Access Compliance Report

Public Rights-of-Way

(Curb Ramps)

Intersection ID: 15747	Main Street: PRESSLEY_RD	Cross Street: ROSE_THORN_PL	Location: SE
ADA ID: C5E5427B69A7	Ramp Type: Directional1	Initial Pass/Fail: Fail	Overall Compliance: No
Severity Score: 25			
Codes/Mitigation Info/Possible Solution		Field Measurements/Component Compliance

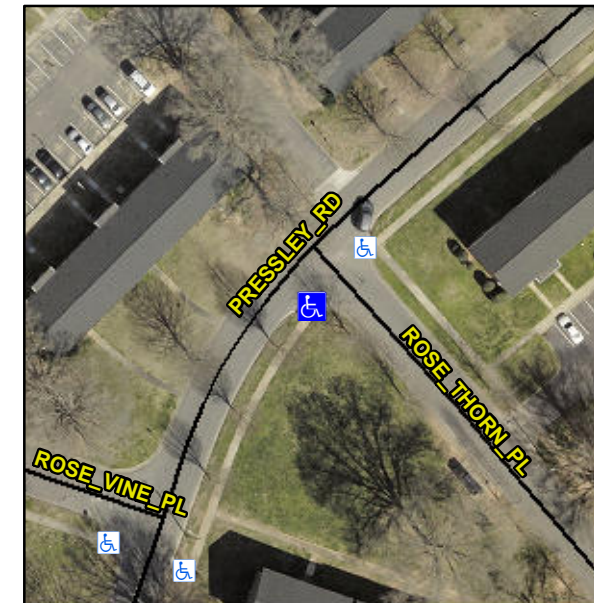
R304.2.2, R304.5.3

Compliance	Description	Data	Compliance	Description	Data
N/A	Ramp Length (in)	84.0	N/A	Grade Break?	N/A
Yes	Ramp Width (in)	60.0	N/A	Grade Break Slope (%)	0.0
No	Ramp Slope (%)	8.6	N/A	Grade Break XSlope (%)	0.0
No	Ramp XSlope (%)	5.6			
N/A	Flare Type LT	N/A	N/A	Flare Type RT	N/A
N/A	Flare Slope LT (%)	N/A	N/A	Flare Slope RT (%)	0.0
N/A	Flare Traversable LT?	N/A	N/A	Flare Traversable RT?	N/A
N/A	Landing Length (in)	0.0	N/A	DWS Provided?	N/A
N/A	Landing Width (in)	0.0	N/A	DWS Contrast?	N/A
N/A	Landing Slope (%)	0.0	N/A	DWS Length (in)	N/A
N/A	Landing X Slope (%)	0.0	N/A	DWS Full Width?	N/A
N/A	Landing Curb? (Y/N)	N/A	N/A	DWS Offset LT (in)	N/A
N/A	Shared Landing?	N/A	N/A	DWS Offset RT (in)	N/A
N/A	Gutter Ponding?	0.0	N/A	Gutter Slope (%)	N/A
N/A	Gutter Lip Ht (in)	0.0	N/A	Gutter X Slope (%)	N/A
N/A	Painted X Walk1?	No		Road Slope (%)	1.2
	X Walk 1 Direction	To NE		Road X Slope (%)	1.2
	X Walk 1 Width (in)	N/A		Clear Space?	N/A

Remove & Replace Entire Ramp.
